5DX-79-S

S E R V I C E N O T E

5DX Series II, Series 2L, Series 3 and Series 5000 Systems

POSSIBLE ELECTRICAL SHOCK HAZARD

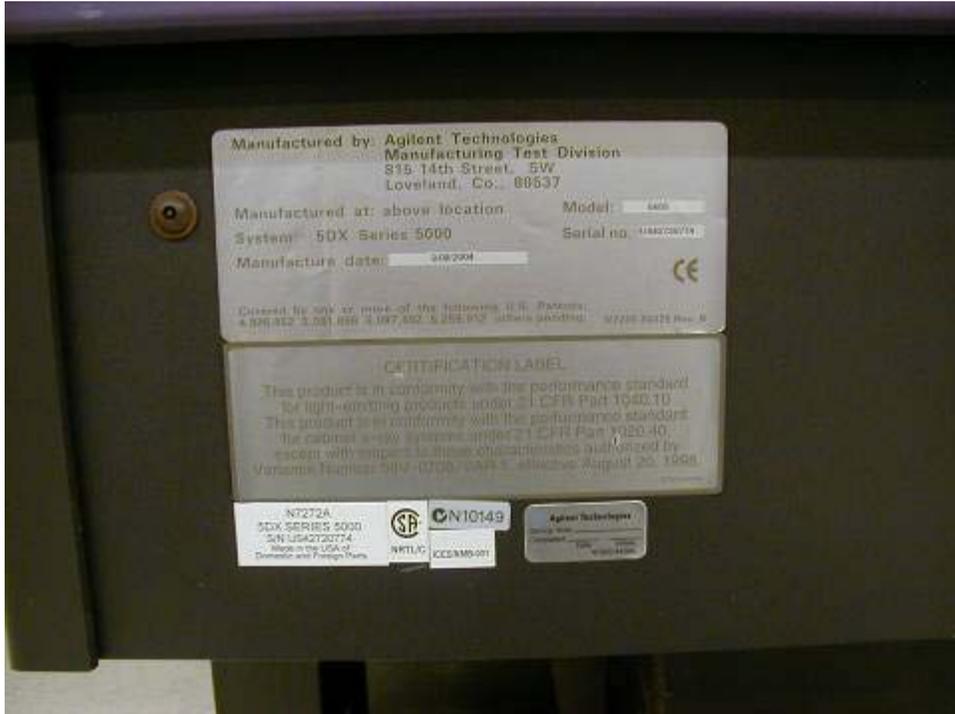
4. With the power cord securely inserted in the “AC Module” forcibly pull the power cord to the right side two times and see if the “AC Module” pulls out from instrument.

5. If the “AC Module” pulls out of instrument you will need to replace the E3615A. If the “AC Module” remains in place skip to step 13.
